Report: Issues

Function: Test, Adjust, & Balance

CW 2999 - UTSW (DALLAS, TX)

Issue Name : VRH-3-22

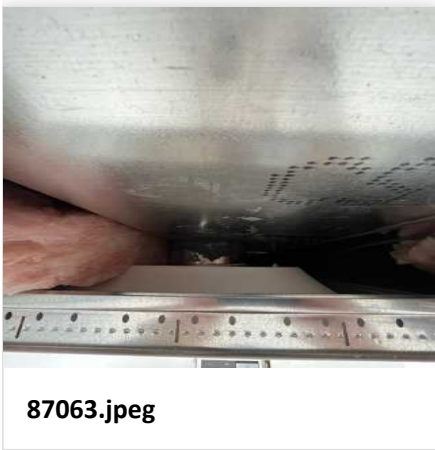
Description : Diffuser 4 does not have a damper and is thus extremely high on CFM. The diffusers is extremely close to the main duct as well.
